COUNCIL ASSESSMENT REPORT

SYDNEY EASTERN CITY PLANNING PANEL

PANEL REFERENCE & DA NUMBER	PPSEC-281 – [DA/168/2023]
PROPOSAL	Construction and use of five (5) buildings for mixed uses including student accommodation, UNSW university space, retail premises, communal and publicly accessible open space (West Mall), and basement car parking.
ADDRESS	Lot 2 DP 1173179 215B Anzac Parade, Kensington
APPLICANT	University of New South Wales (UNSW) - Clare Hall
OWNER	University of New South Wales
DA LODGEMENT DATE	11 May 2023
APPLICATION TYPE (DA, Concept DA, CROWN DA, INTEGRATED, DESIGNATED)	CROWN DA / INTEGRATED DEVELOPMENT
REGIONALLY SIGNIFICANT CRITERIA	Section 2.19(1) and Clause 4 of Schedule 6 of State Environmental Planning Policy (Planning Systems) 2021 declares the proposal regionally significant development as the development has a cost of works greater than \$5m.
CIV	\$227,656,927 (excluding GST)
CLAUSE 4.6 REQUESTS	Randwick LEP 2012 - Clause 4.3 Height of Buildings to be varied and SP2 Special Infrastructure

Figure 19: shows the signage location on buildings A, B and C as amended in architectural design report submitted July 2024.

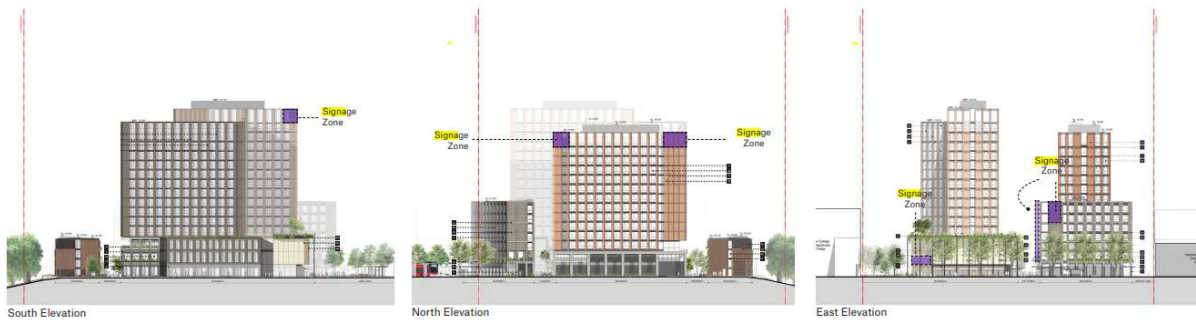
Sign emplacements on the lower levels up to 7th storey will not protrude from building envelopes. The sign emplacements at the top levels of Buildings A and B compete with vistas that take in the main UNSW signage on the library building in the main campus as shown in Figure 19.

Figure 23: buildings within the development site and heights proposed.

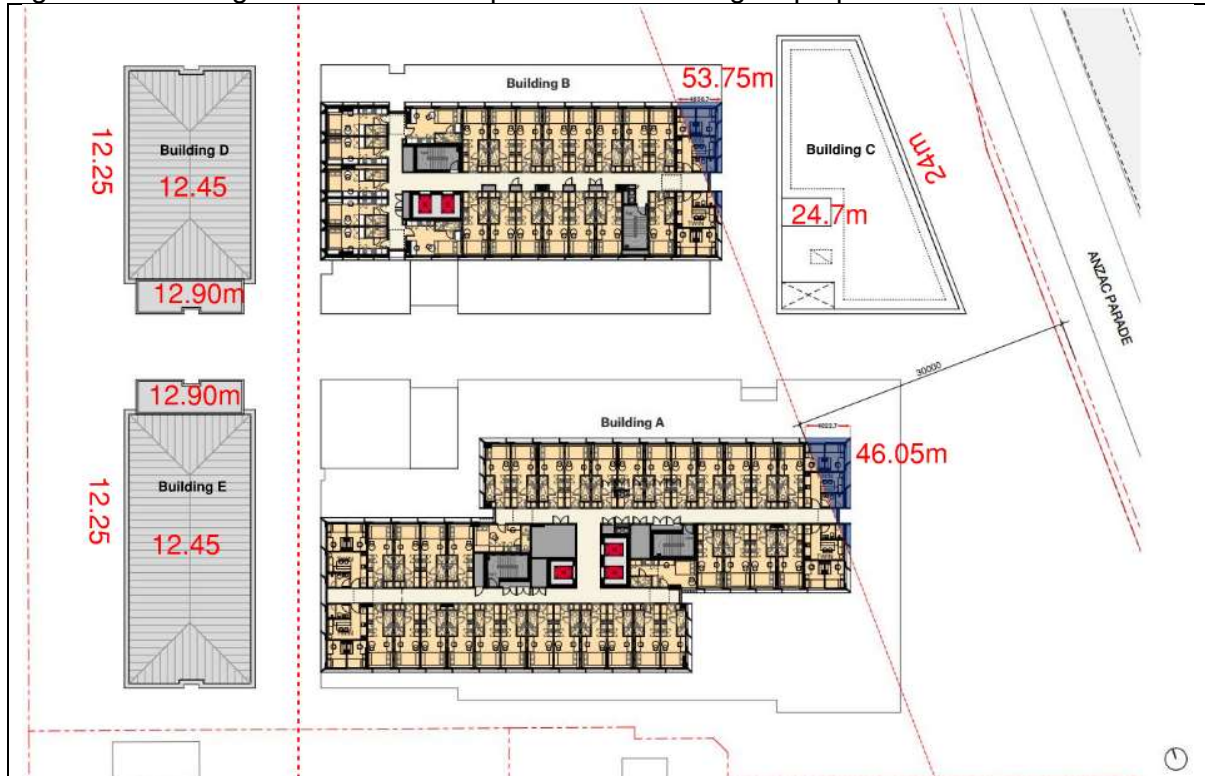
For Buildings A and B, the planning grounds are not considered sufficient as the encroaching-built forms elements do not satisfy the objectives of the standard or the zone noting that these buildings will result in adverse visual bulk and overshadowing well beyond those envisaged for the site (close to double the maximum RLEP and RDCP height provision) and the surrounding area.

Figure 24: LEP height maximums under the Planning proposal at left and current height standards applicable to the site.

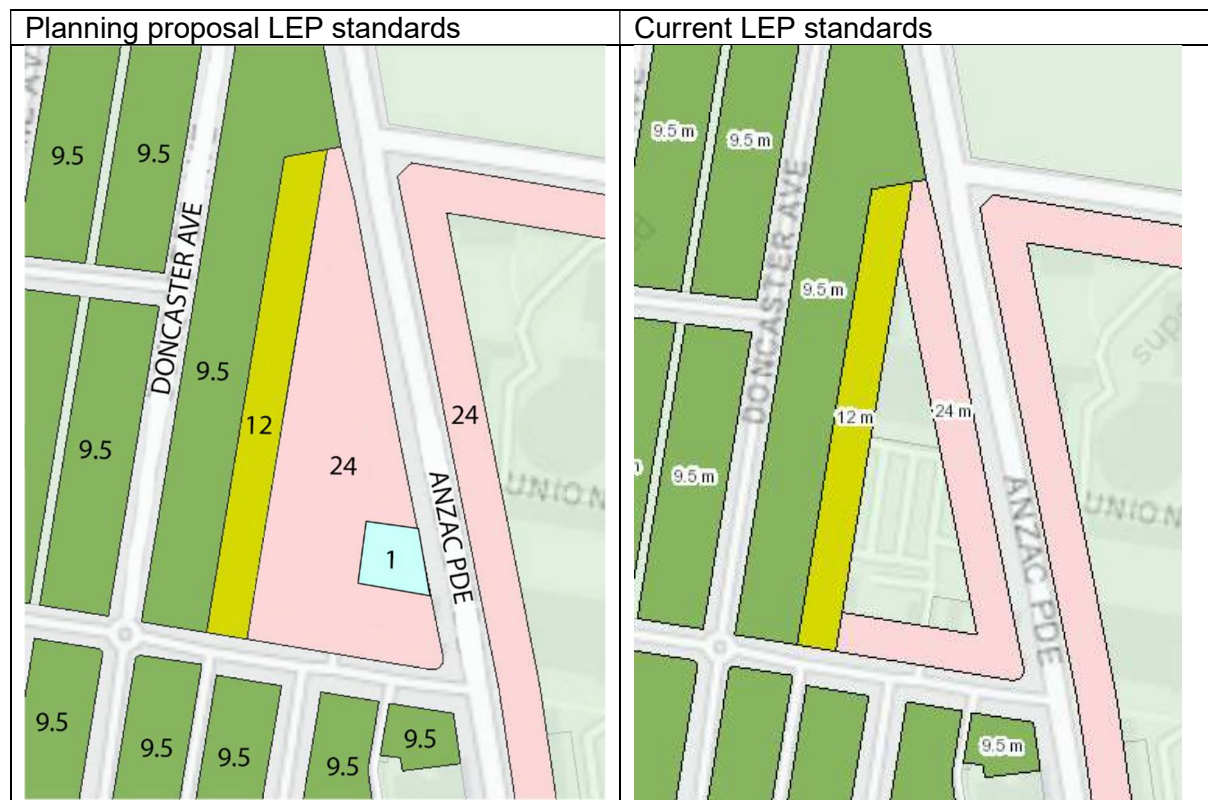
The proposed development is inconsistent with the planning proposal provisions namely in relation to the height of building A and B being consistent with the variations sought to the current LEP and DCP controls applicable to the site. Building C also encroaches into the alignment controls requiring a larger front setback from the Anzac Parade frontage behind the NIDA buildings top two levels and the Building B setback is less than the 18m recommended setback.

Figure 32: Rendered image of development façade as amended showing size of NIDA in background.

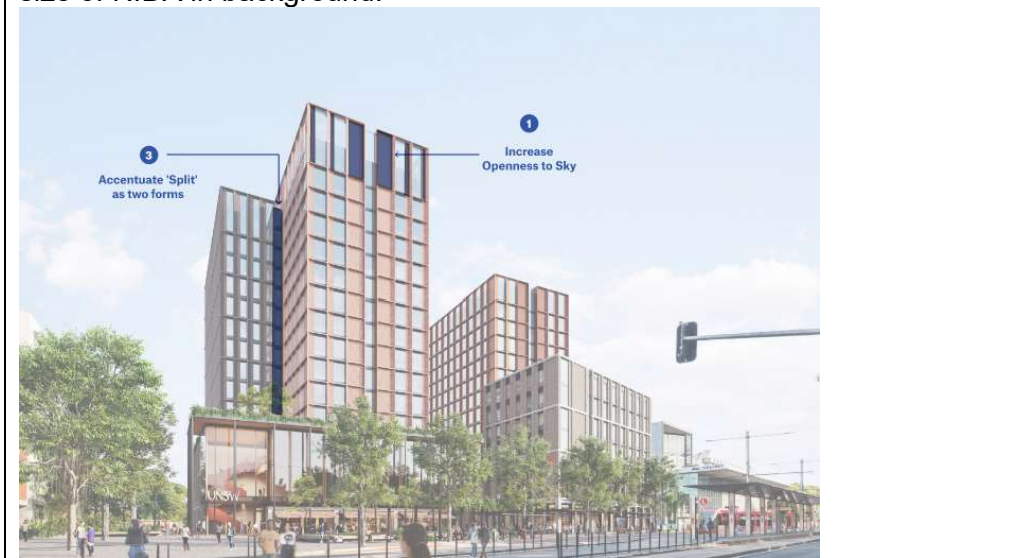
The applicant's response to the DEAP advice is acknowledged as providing a slight differentiation between the two buildings and assist in reducing some of the concerns associated with the differentiation and scale of the proposal. However, the predominant concerns regarding building separation, overall height and the bulk of the proposed floor plates

Figure 36: shadow cast by the proposed building A and B at 9am at the winter solstice.

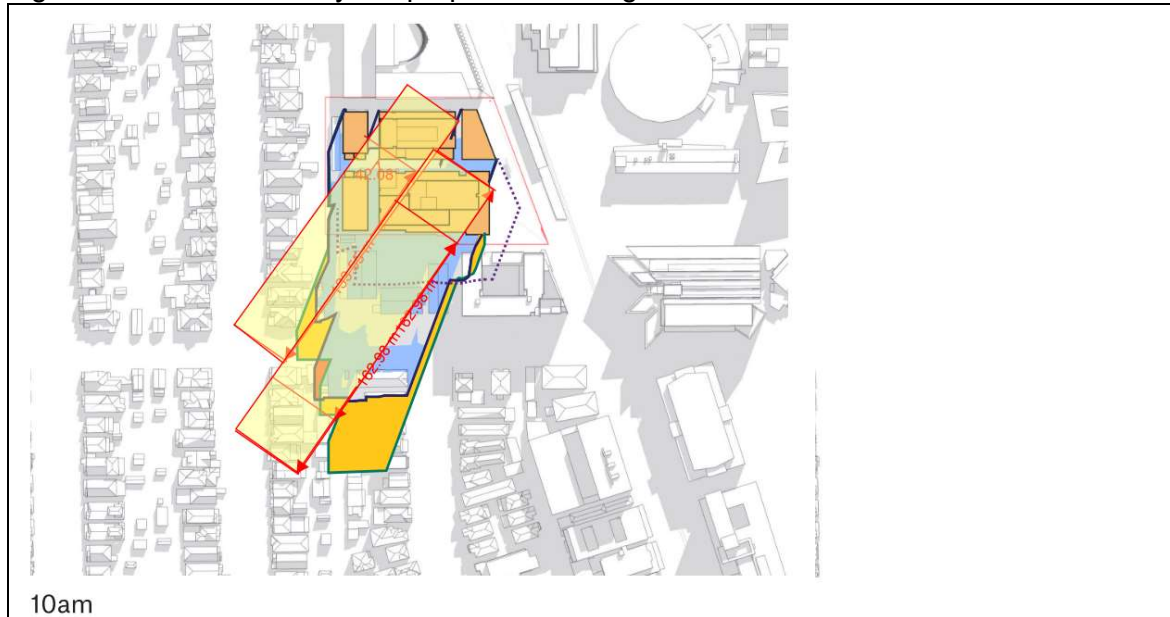
As noted in the clause 4.6 assessment, the application includes a detailed shadowing analysis of properties immediately adjoining the site. Notably those that front Day Avenue in the Medium density zone are modelled to retain at least three hours of solar access to their north facing windows.

Overshadowing as a result of the whole of Buildings A and B are contained within a built form that results in the rear elevations of adjoining buildings at No. 226 to 232 Doncaster having their solar access reduced to less than they currently receive, which is assumed to be less than 3 hours due to the subdivision development pattern and angle of the sun at 12pm. It is noted that a compliant scheme would partially overshadow the rear elevations of these properties, and whilst the row of retained trees will cast a shadow to the rear of these properties, they are not dense structures comparable to the built form under the subject application.

Resolution: The issue is not resolved and should be grounds for refusal.

Figure 36: Section plan showing the separation between buildings A and B and to the NIDA building to the north.

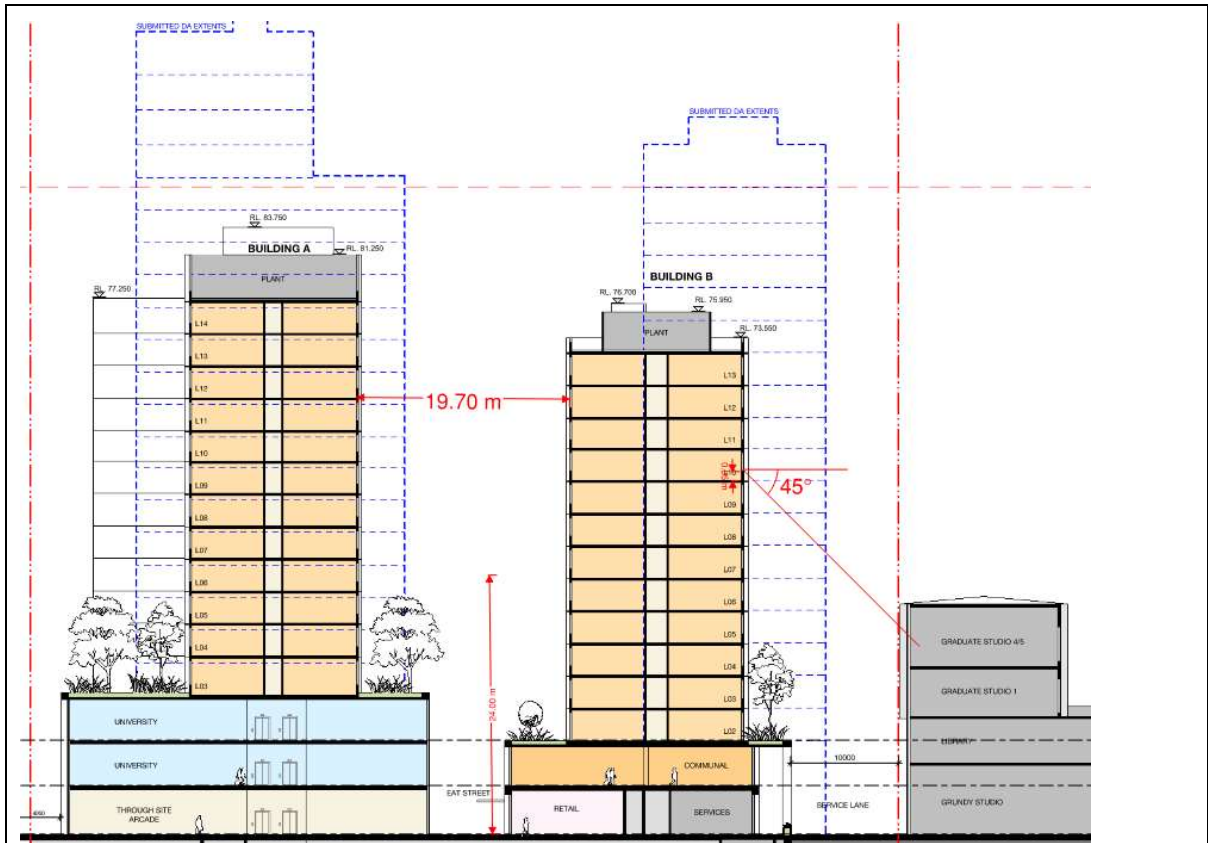
Although Building B which is 10m to 14m away from the boundary shared with NIDA's northern elevation (shown in image below), there is a line of sight towards NIDA teaching facilities noting that the perforated screen may not achieve the levels privacy screening it achieves during the daytime.

Figure 37: Layout of additional privacy measures to building B and C.

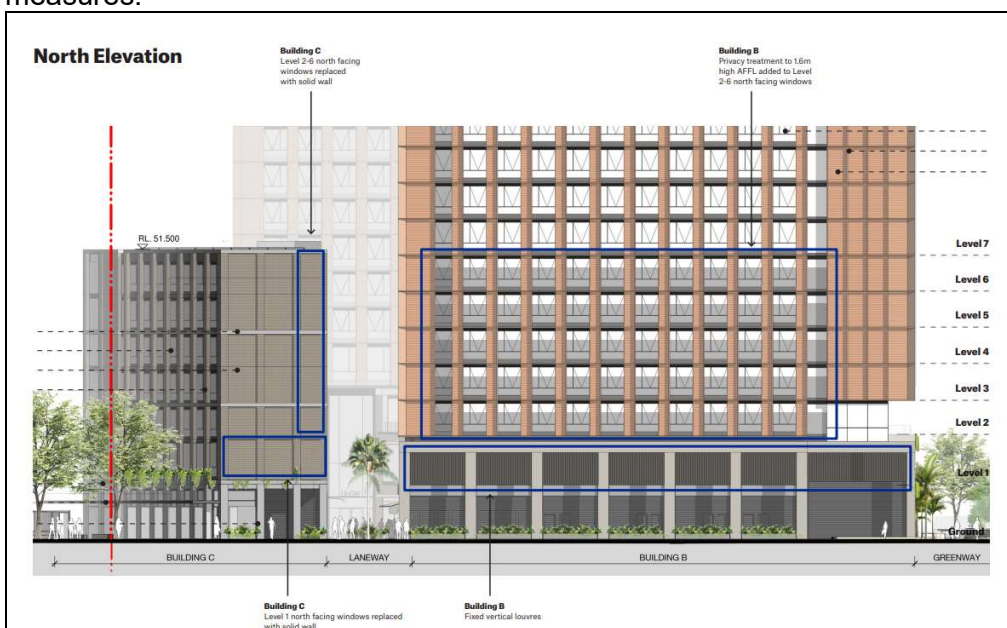
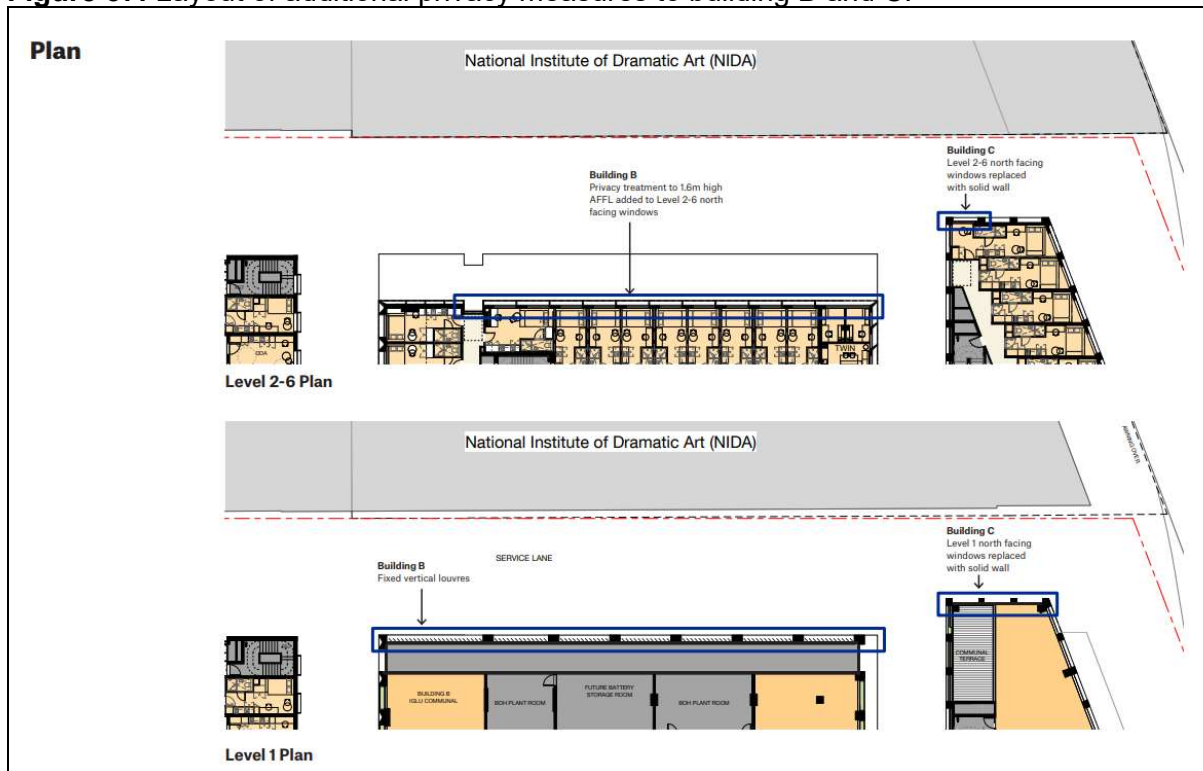
The applicant submitted additional details (shown in figures below) seeking to address privacy form Building B and C – providing for Building B, level 01 with louvres, and for levels 02 to 06 to accommodate 1.6m high obscured glazing and limited opening of windows and for Building C with privacy measures through the deletion of openings.

Planning comment on proposed privacy measures:
